Re: Agnico Eagle Mines – Meadowbank Division Responses to Whale Tail WRSF, NPAG and Overburden Stockpile Design Report Comments

- CIRNAC – December 7, 2018, Crown-Indigenous Relations and Northern Affairs Canada (CIRNAC) comments on Agnico Eagle Mines Limited's (AEM's) Waste Rock Storage Facility (WRSF), Non-Potentially Acid Generating (NPAG) Stockpile and Overburden Stockpile Design Report and Drawings – Whale Tail Pit Project under AEM's Type "A" Water Licence No. 2AM-WTP1826.

1.1 Drawing: Whale Tail WRSF Layout

Figure 1: AMQ15-324 thermal profile

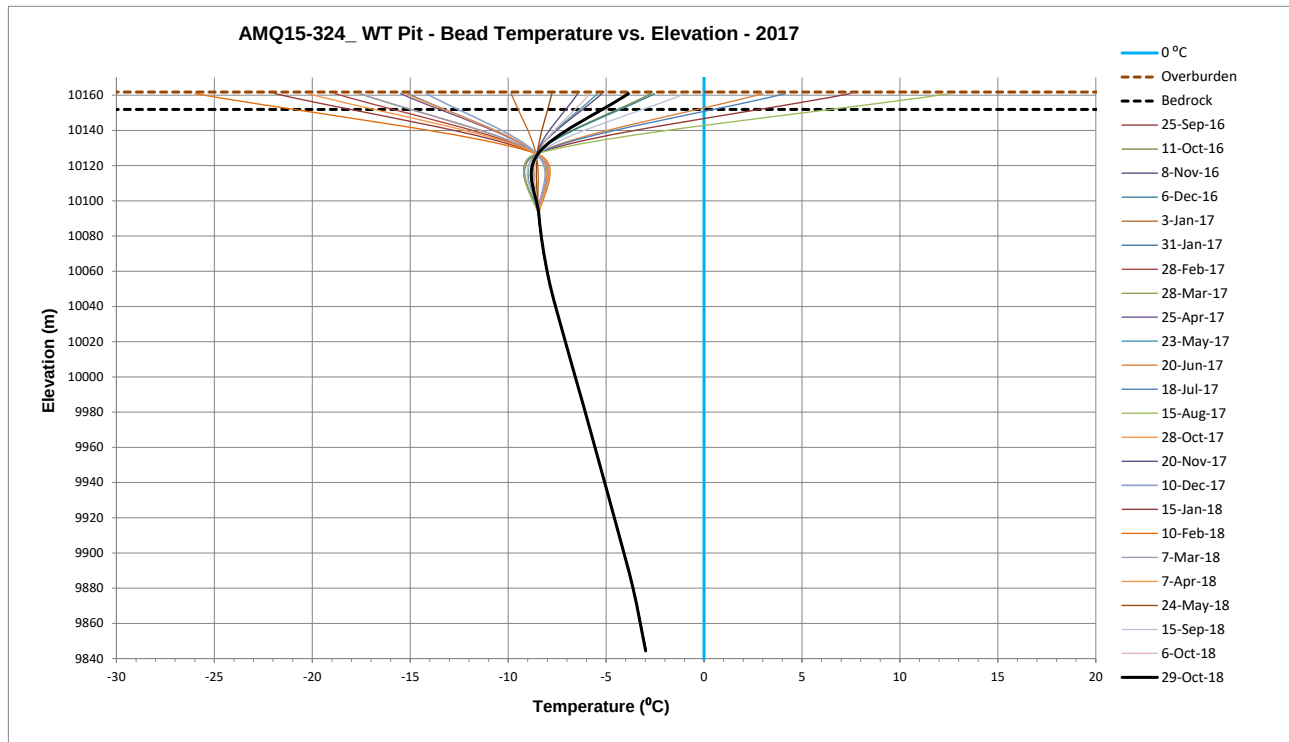
Comment 2: AEM's design report states "the typical depth of the active layer is 2 m in this region of Canada. The typical permafrost ground temperatures at the depths of zero annual amplitude (typically at the depth of below 15 m) is approximately -8.0 °C in areas away from lakes and streams." CIRNAC requests the thermistor details and temperature profile be provided for the aforementioned measurements at the Whale Tail Pit site.

A memo summarizing the thermal monitoring program at Whale Tail Pit Project from the period of 2015 to 2018 is presented in Appendix 1. Find below selected thermal profiles from this memo that specifically provide answers related to the zero annual amplitude and the permafrost temperature (-8 °C). As for the active layer depth, this will vary depending on the material. The 2 meters mentioned refers to natural overburden. The FEIS documents mention that: "the depth of the active layer ranges from about 1.3 m in areas with shallow overburden, up to about 4 m adjacent to lakes". (FEIS Appendix 5 –A: Terrain, Permafrost, and Soils Baseline Report) Coarser rockfill material (WRSF) will have a deeper active layer due to additional warm convective airflow during summer.

AMQ15-324: This 300 meters depth thermistor, installed west of the lake, provides a good example of a thermal profile away from lakes and streams. As shown in the profile, temperatures reach approximately -8.0 °C at elevation 10 150 (150 m.a.s.l.).
